**Beaver Valley Power Station
Unit Nos. 1 and 2**

**License Amendment Requests
302 and 173**

Extended Power Uprate

L-04-125

FIGURE 3.4-1
DOSE EQUIVALENT I-131 Primary Coolant Specific Activity Limit
Versus Percent of RATED THERMAL POWER with the Primary
Coolant Specific Activity > 0.400,35 $\mu\text{Ci/gram}$ DOSE EQUIVALENT I-131

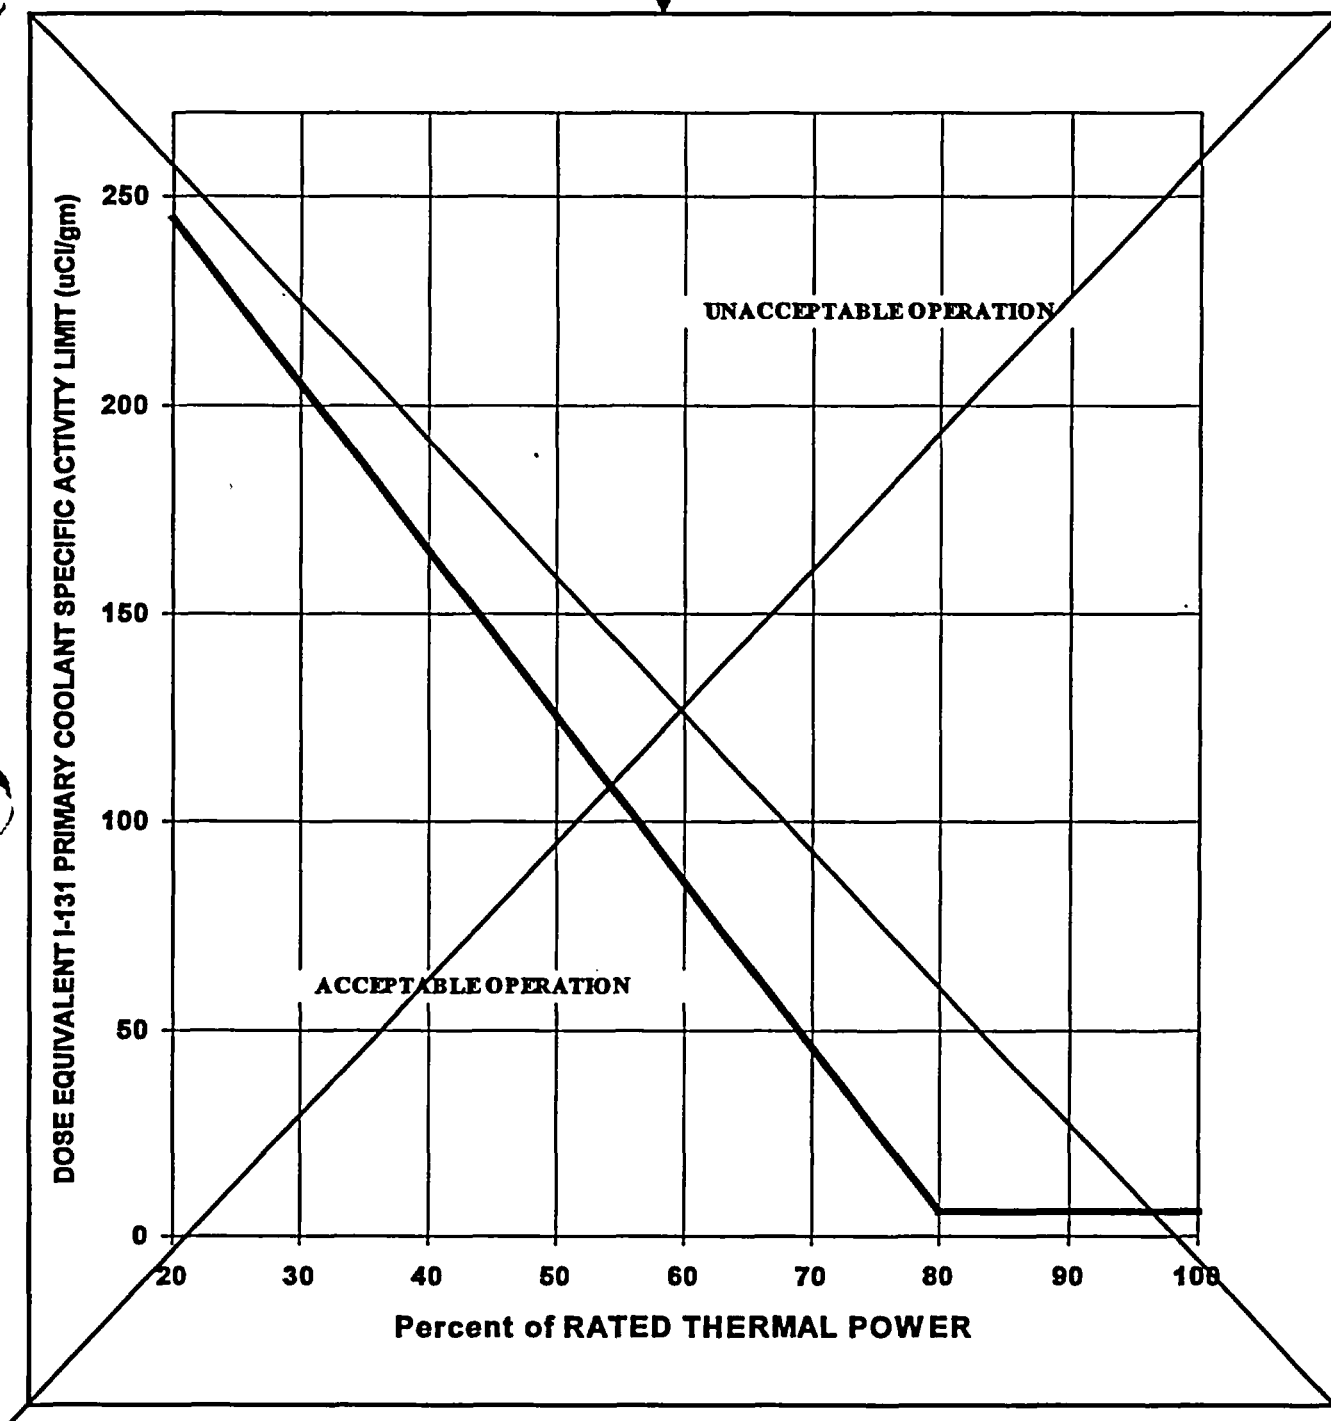
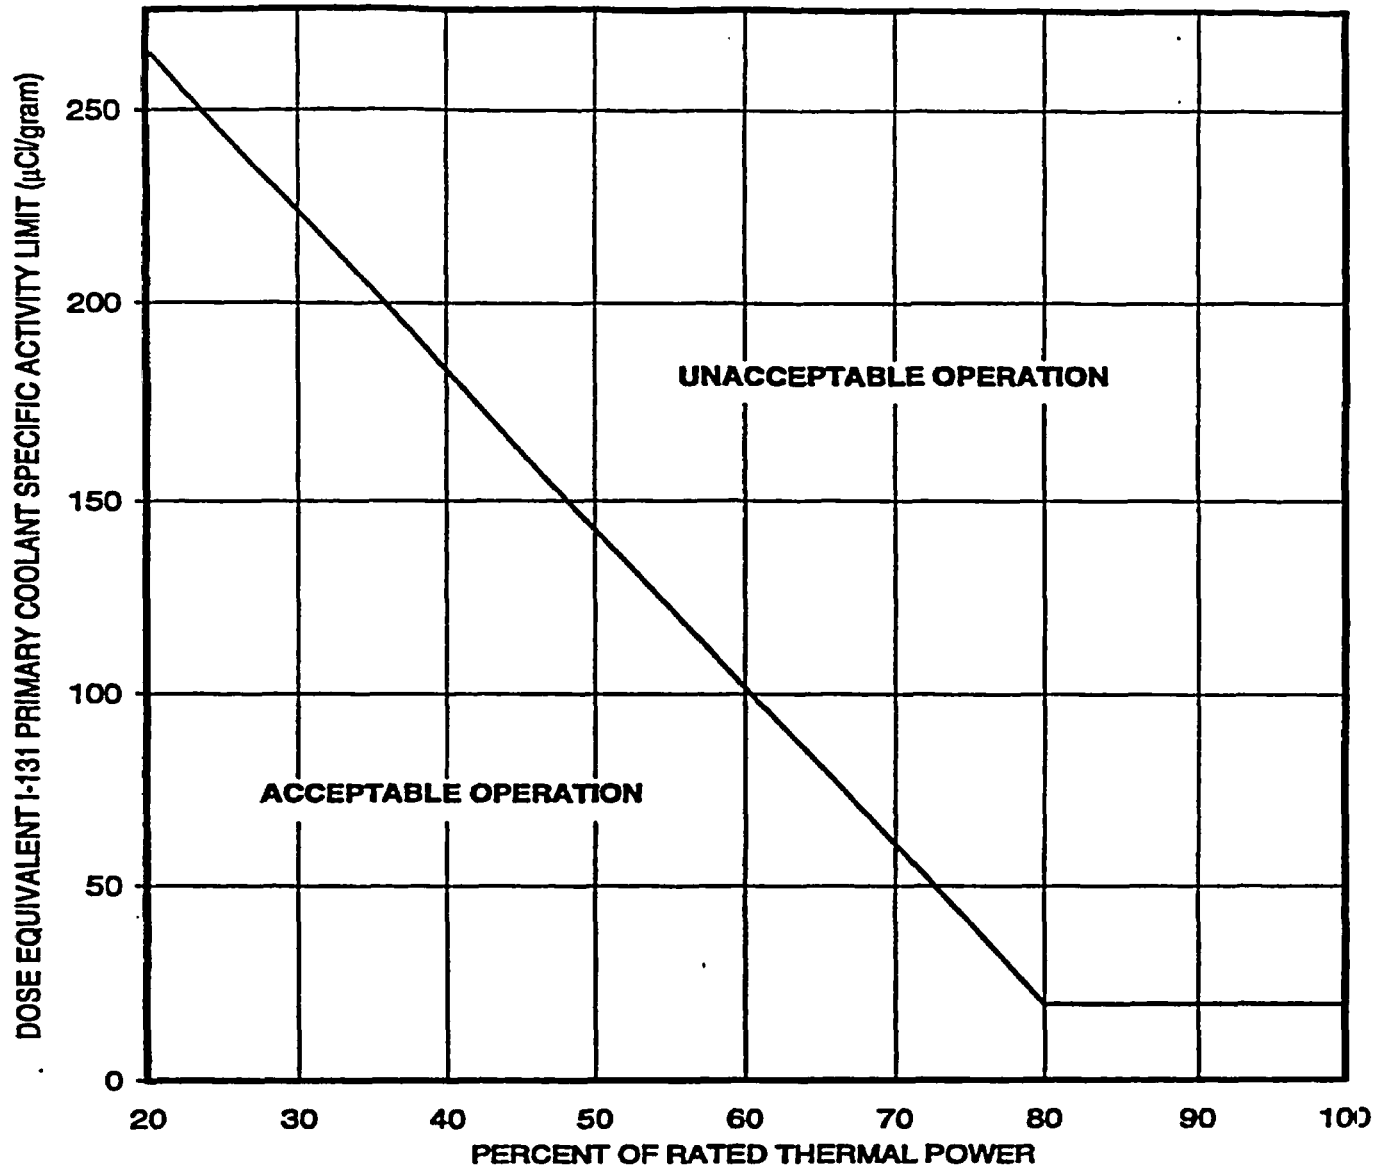
- a. With the specific activity of the primary coolant $> \cancel{0.100.35} \mu\text{Ci/gram DOSE EQUIVALENT I-131}$ ⁽¹⁾ for more than 48 hours during one continuous time interval or exceeding the limit line shown on Figure 3.4-1, be in HOT STANDBY with $T_{\text{avg}} < 500^\circ\text{F}$ within 6 hours.
- b. With the specific activity of the primary coolant $> 100/\bar{E} \mu\text{Ci/gram}$, be in HOT STANDBY with $T_{\text{avg}} < 500^\circ\text{F}$ within 6 hours.

Replace with Insert A1-1.

Insert A1-1.

Figure 4.2-1
Reactor Coolant System Heatup
Limitations Applicable for the First 22-21 EFPY (TS 3.4.9.1)

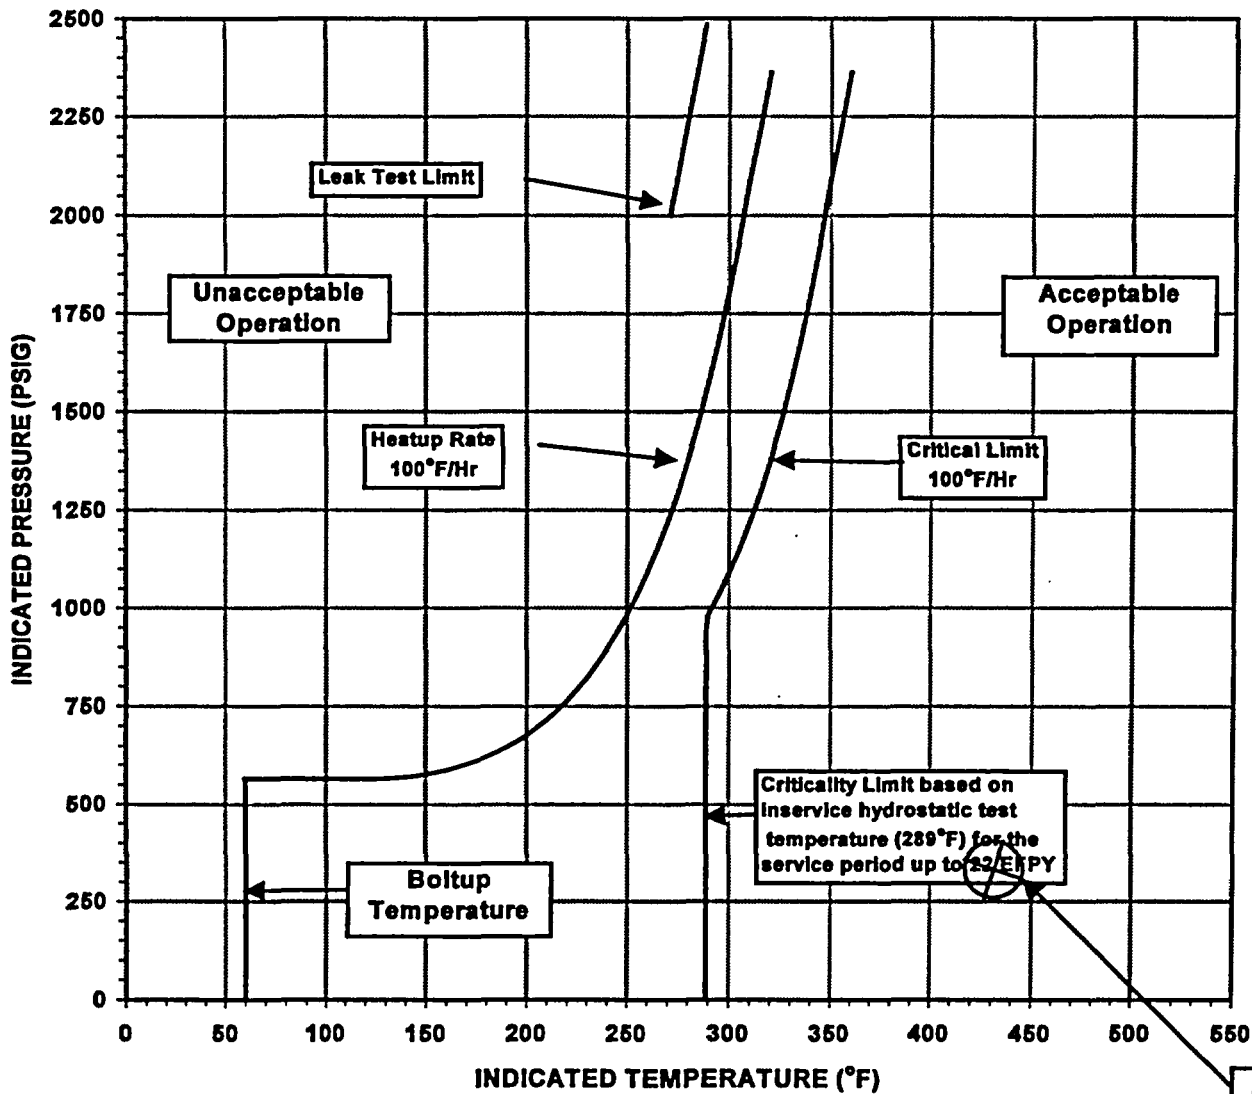
1/4T, 233°F

3/4T, 196°F

Figure 4.2-1
 Reactor Coolant System Heatup
 Limitations Applicable for the First 1422 EFPY (TS 3.4.9.1)

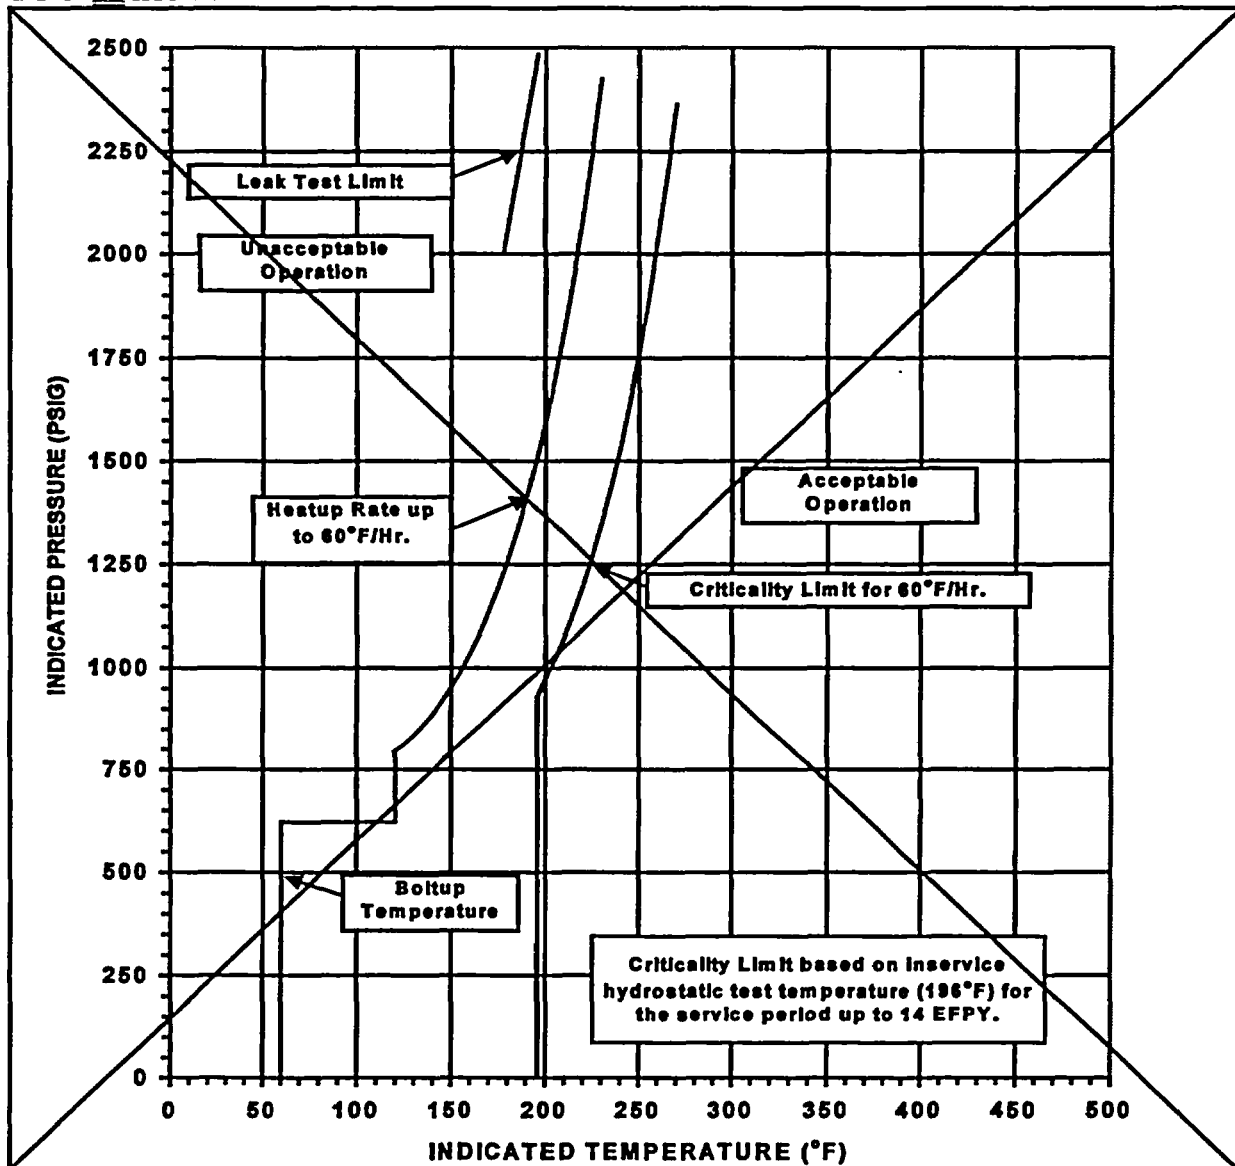
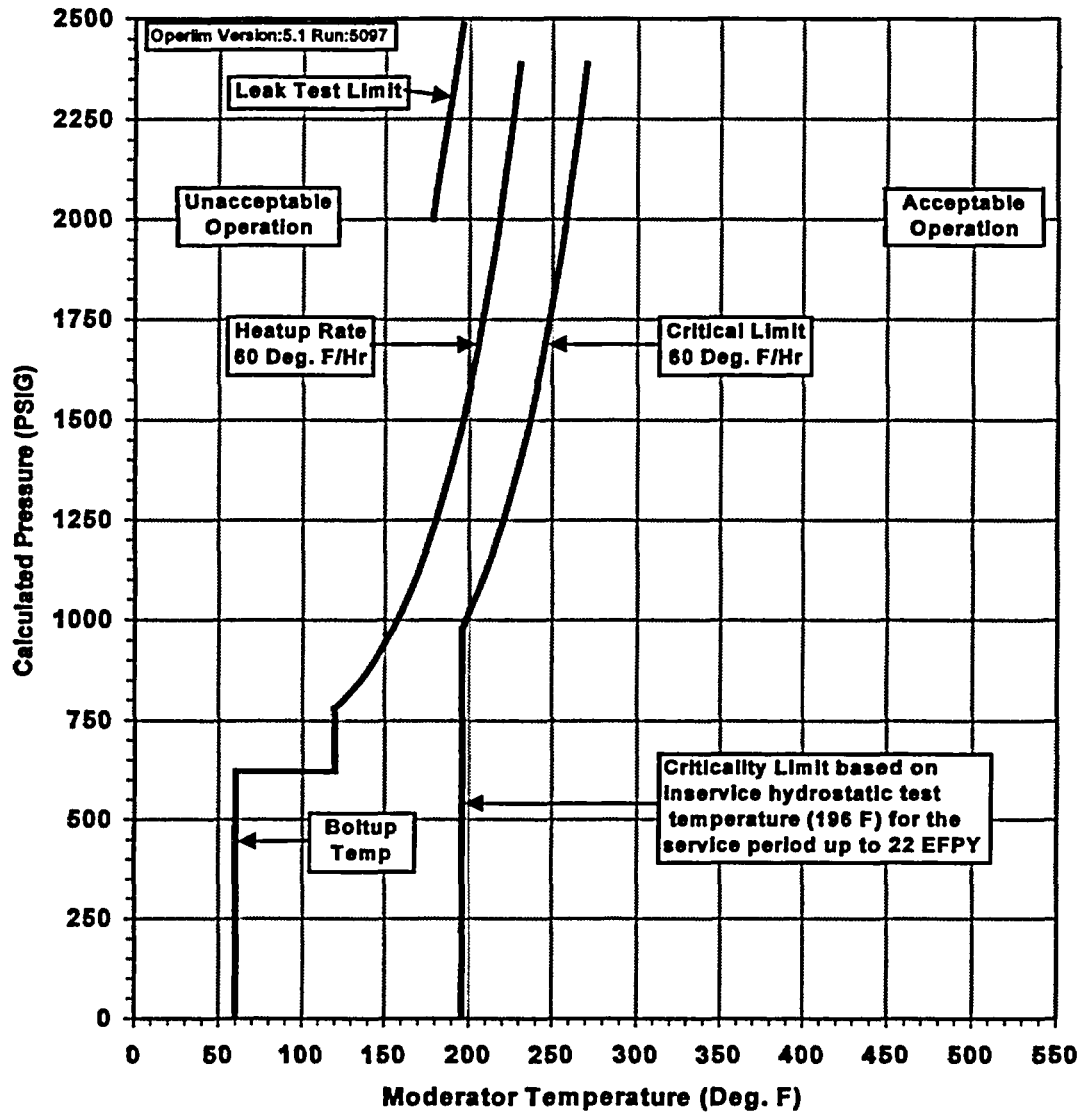
CONTROLLING MATERIAL: INTERMEDIATE SHELL PLATE B9004-1
 INITIAL RT_{NDT}: 60°F
 RT_{NDT} AFTER 1422 EFPY: 1/4T, 140°F
 3/4T, 128, 129°F

CURVES APPLICABLE FOR HEATUP RATES UP TO 60°F/HR FOR THE SERVICE PERIOD UP TO 1422 EFPY.

Replace with
 Insert C2-4.

Insert C2-4.

Reactor Coolant System Cooldown (up to 0°F/Hr.)
Limitations Applicable for the First 1422 EFPY (TS 3.4.9.1)

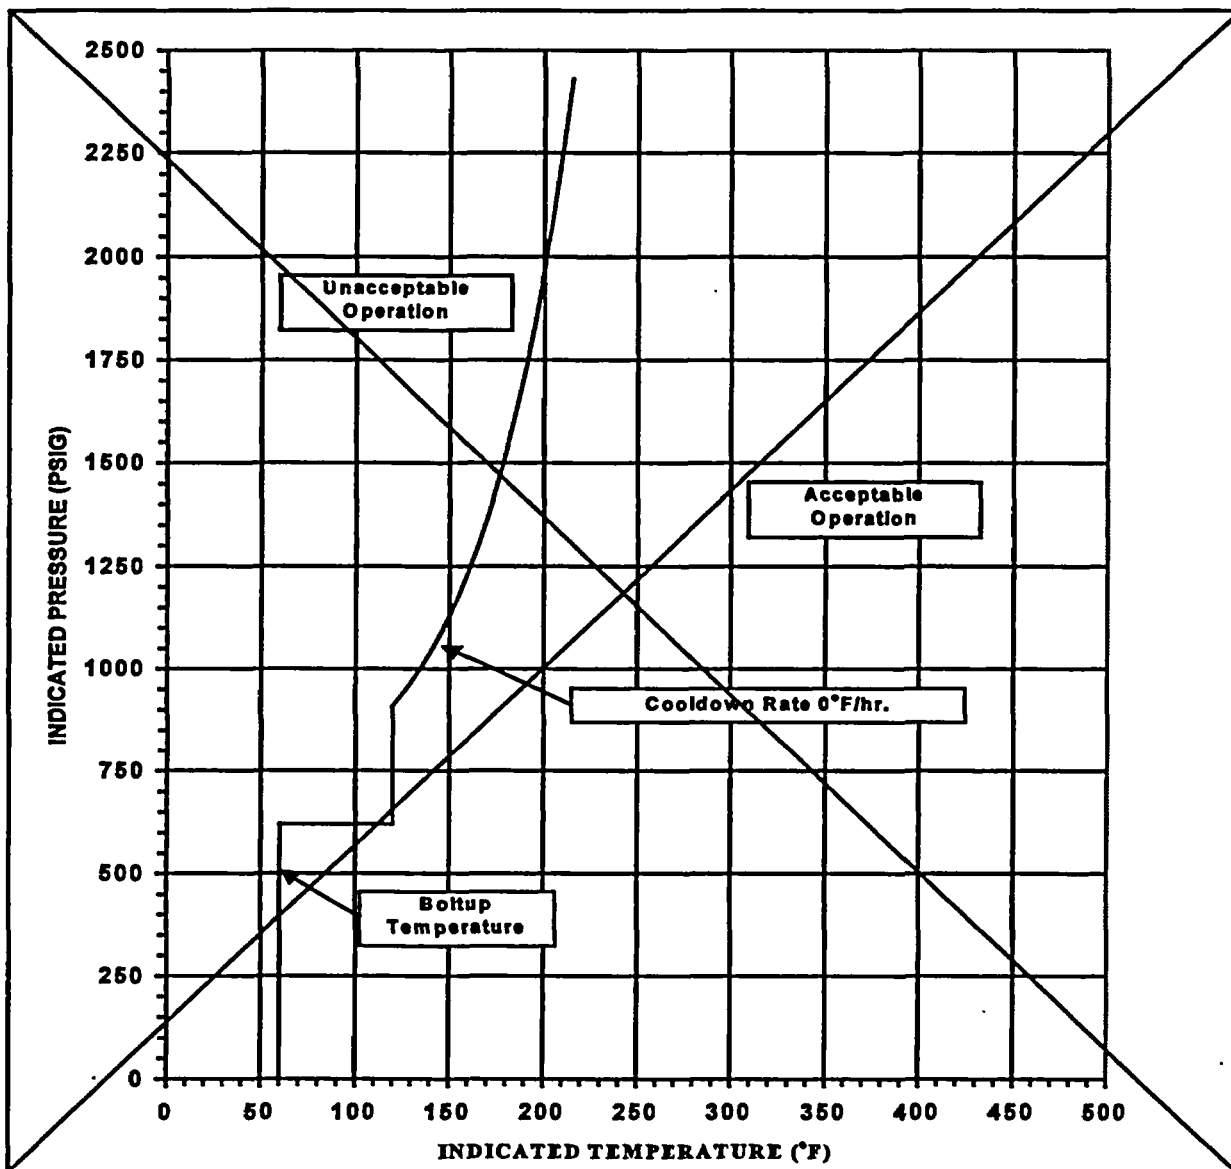
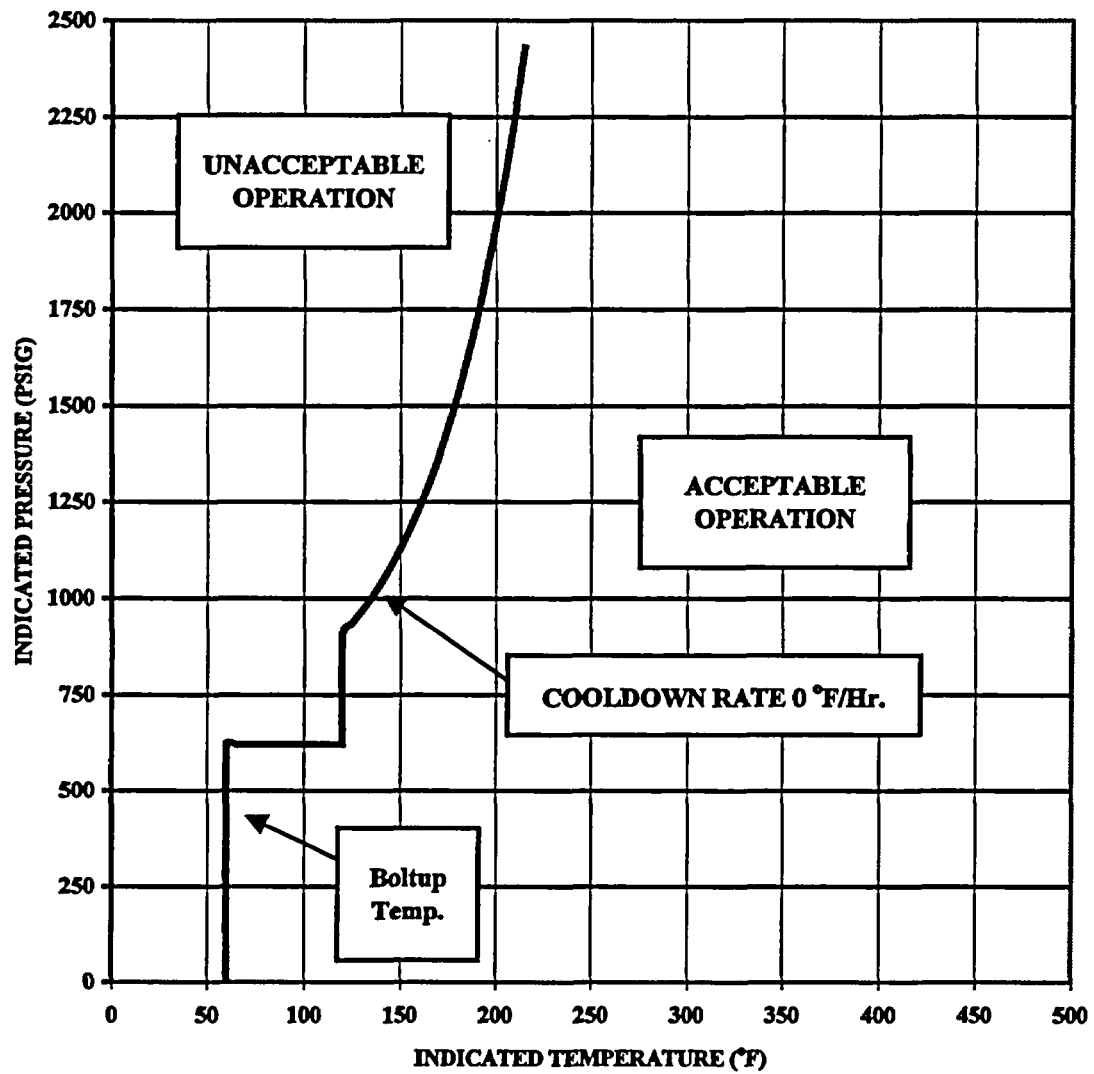
RT_{NDT} AFTER 1422 EFPY: 1/4T, 140°F
3/4T, 128129°F

CURVE APPLICABLE FOR COOLDOWN RATES UP TO 0°F/HR FOR THE SERVICE PERIOD UP TO 1422 EFPY.

Replace with
Insert C2-5.

Insert C2-5.
